Attachment D

PG&E's Comments on the North Fork Feather River Listing for Polychlorinated biphenyls (PCBs)

WATER SEGMENT:	North Fork Feather River below Lake Almanor (The 2008 proposed listing includes the entire 56+ mile stretch – without any segmentation)
POLLUTANT:	PCBs
SOURCES:	Source Unknown
STATUS of Proposed 2008 303(d) LISTING:	List (2006 decision was Do Not List)
CVRWQCB STAFF BASIS:	After review of the available data and information, Central Valley Regional Water Quality Control Board (CVRWQCB) staff concludes that the water body-pollutant combination should be placed on the section 303(d) list because applicable water quality standards are exceeded and a pollutant contributes to or causes the problem.
PG&E RECOMMENDATION:	Revise listing as follows: <u>List NFFR Belden Reach (between Belden Forebay and Belden Powerhouse);</u> <u>List Poe Reach (Poe Reservoir only); and</u> <u>List NFFR Big Bend Reach (Big Bend Reservoir only);</u> <u>Do Not List any other NFFR reaches.</u>
PG&E COMMENT:	<p>The CVRWQCB listed the entire NFFR below Lake Almanor in the Seneca Reach through the Big Bend Reach to Lake Oroville due to exceedances of Office of Environmental Health Hazard Assess

Figure D-1. Water Segment Delineation and Actual Sampling Locations in the NFFR for PCBs (PG&E data 2001, 2002, and 2003), (Belden Forebay, NFFR below Belden Dam, NFFR below dredge disposal site, Poe Reach in Poe Reservoir only, and Big Bend Reach below Poe Powerhouse in Big Bend Reservoir)

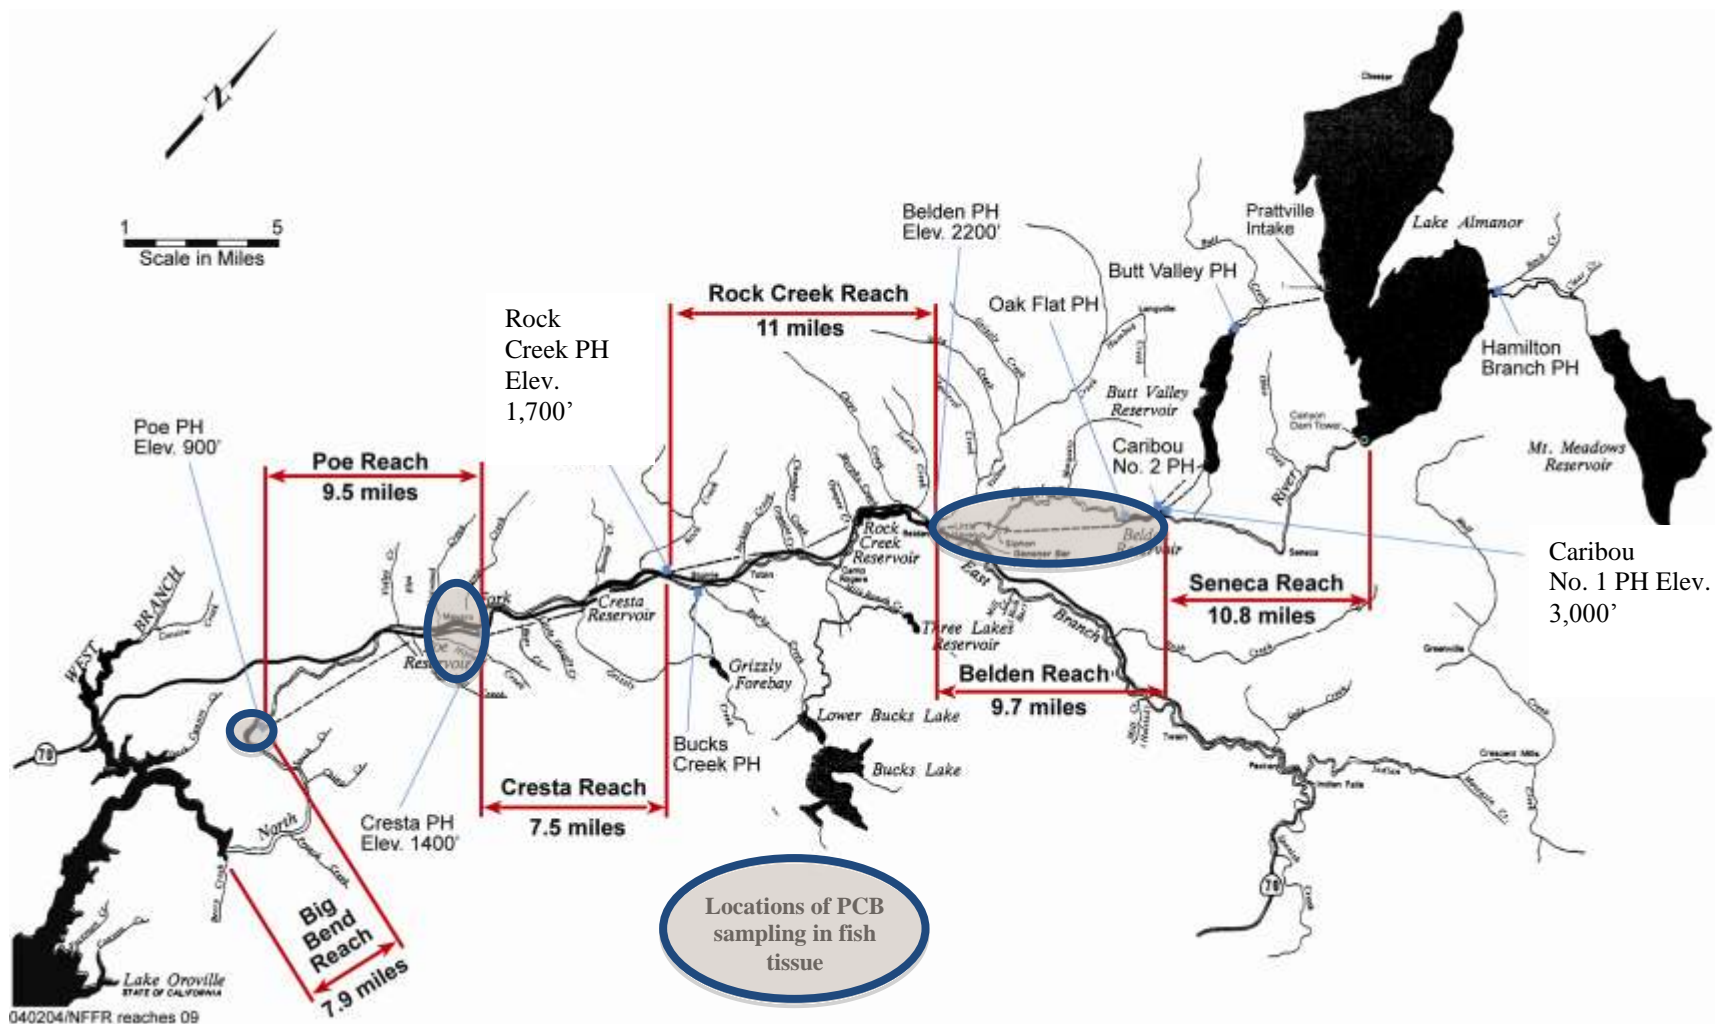
In addition, listing of water segments should be based upon the location of the available data, which in this case is from the Belden Reach (Belden Forebay, the NFFR below Belden Dam, and the NFFR below the dredge disposal site); the Poe Reach (in Poe Reservoir only); and the Big Bend Reach (below Poe Powerhouse in Big Bend Reservoir only). There are no known data and therefore, there is no justification in favor of placing the NFFR below Lake Almanor in the Seneca Reach, Rock Creek Reach, Cresta Reach, or Poe Reach below Poe Reservoir on the section 303(d) list for impaired waterbodies.

PG&E has provided factsheets for each reach of the NFFR (Seneca, Belden, Rock Creek, Cresta, Poe, and Big Bend) in this submission. Factsheets for Seneca Reach, Rock Creek Reach, and Cresta Reach demonstrate that these reaches should not be listed for PCBs because no data is available to make a determination regarding listing. The factsheets for Belden Reach, Poe Reach (in Poe Reservoir specifically), and Big Bend Reach (Big Bend Reservoir specifically) demonstrate that there are data available, which indicate possible impairment due to PCBs and therefore support listing in these water segments only.
